## Nomination Form Anadromous Waters Catalog & Atlas

## AWC Water Body# 247-50-10220-2109-3012

Subject: RE: Nom #24-014 - Reroute/Renumber stream - feedback/follow-up?

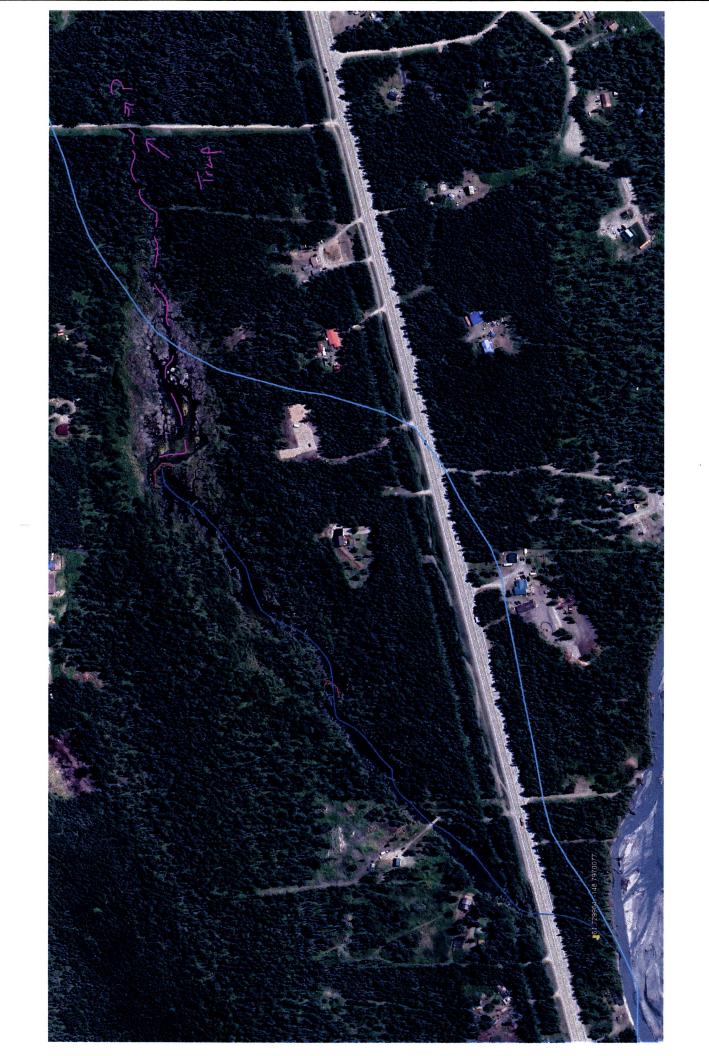
Overall though, all the species observations in the nom record lack specific location data due to the era it was collected in. One Nom (#85-020) mentions the upper extent likely being a beaver dam, however I can see two pretty distinct beaver dams in the google earth imagery from 7/22 (see

attached). So at this point I'm just approximating the upper extent at the upper of the two dams. It would be great to get some updated observations here at some point, particularly since it lists chum & sockeye spawning along with the CO & S rearing. It looks like there is a road that crosses the inlet stream upstream of the ponds which might be a good place to a trap some day and hopefully further validate the upper extent in some manner (juvi's).

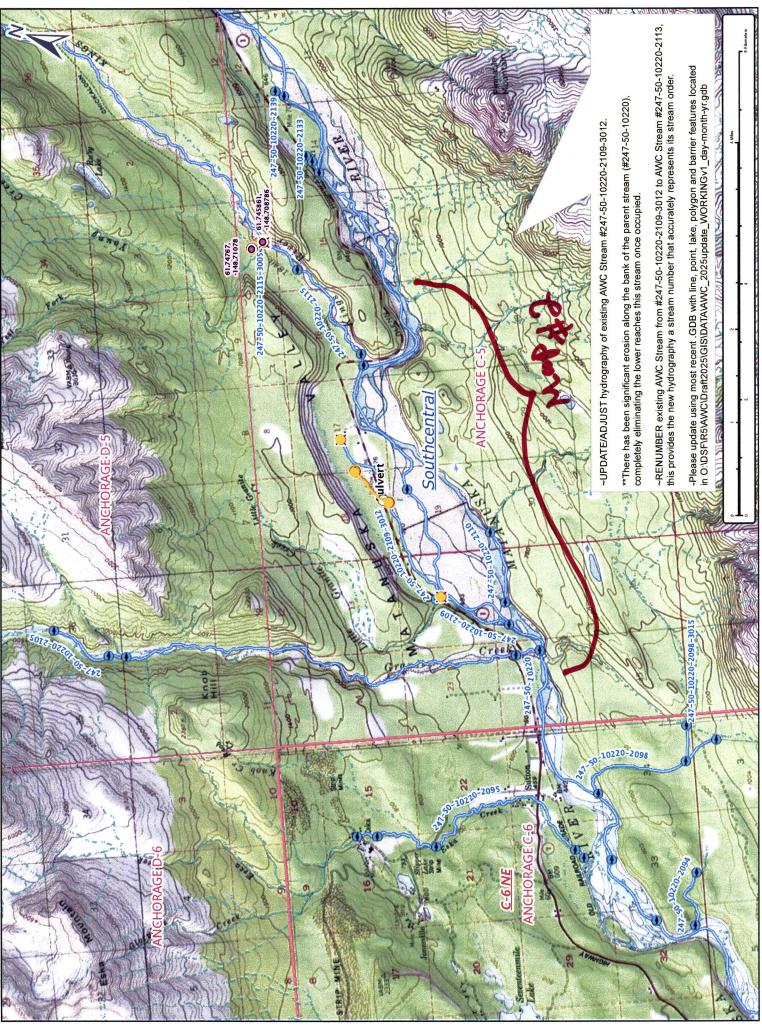
In the attached image I marked the two dams in red, and the pink reach is what's not being captured in this hydrography update.
